**Written submission from  
Gregory Csullog**

Application from the CNL to amend its Chalk River Laboratories site licence to authorize the construction of a near surface disposal facility

**Commission Public Hearing  
Part 2**

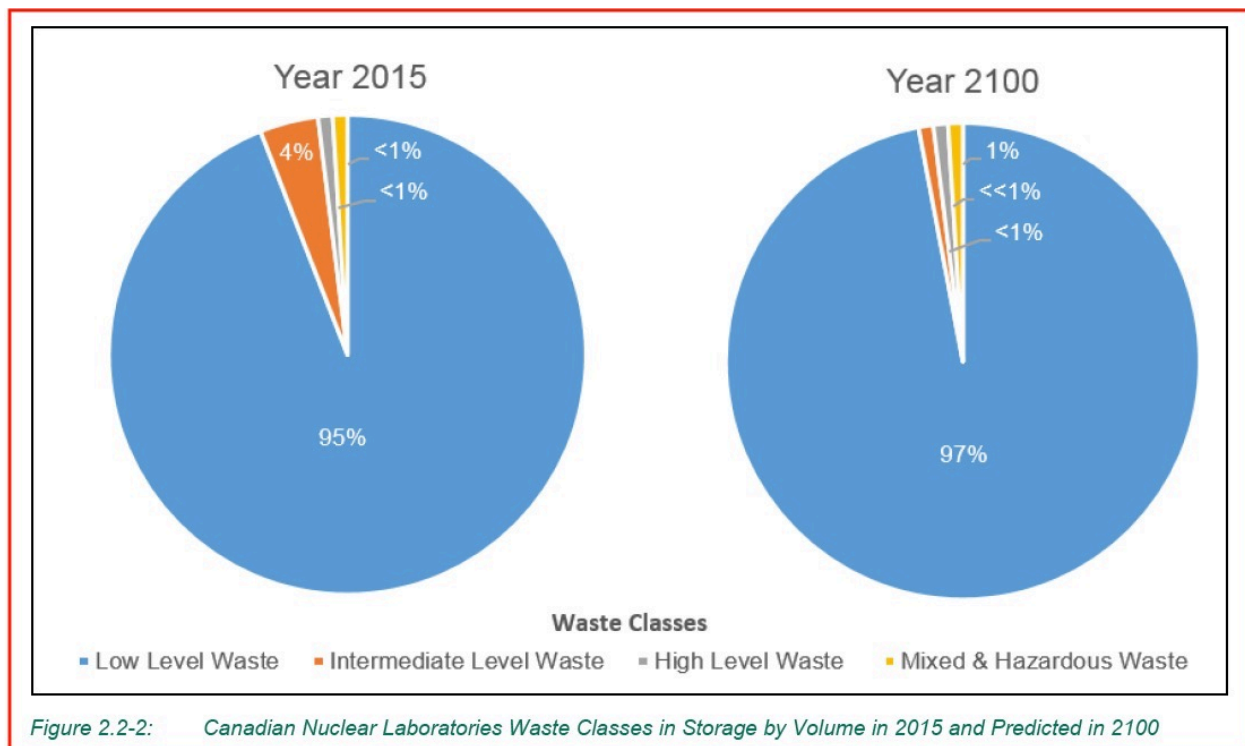
To anyone unfamiliar with radioactive wastes at CRL this might seem reasonable. However, the figure is extremely misleading and the very fact that the proponents of the NSDF used it to justify what wastes would be emplaced into the NSDF is truly worrisome. The fact that the Canadian Nuclear Safety Commission did not take the NSDF project to task over this is disconcerting, to be polite.

The distribution of LLW and ILW in the figure represents, I think properly, the distribution of wastes as generated. However, it does not represent the distribution of LLW and ILW as managed. To put this into context, a little analogy follows.

How does the analogy apply to LLW and ILW. For the vast majority of time that radioactive wastes were generated, collected and stored at CRL, LLW and ILW were not characterized, labeled, and tracked and most were not managed separately. Simply put - a lot of LLW and ILW were stored together in unmarked packages. The amount of long-lived radionuclides that would cause LLW to become ILW is so low that mixing a small amount of ILW with LLW would mean the mix of LLW and ILW wastes would have to be re-classified as all ILW, just as contaminating 1000 ml of water with 1 ml of toxic water would turn drinkable water into non-drinkable water.
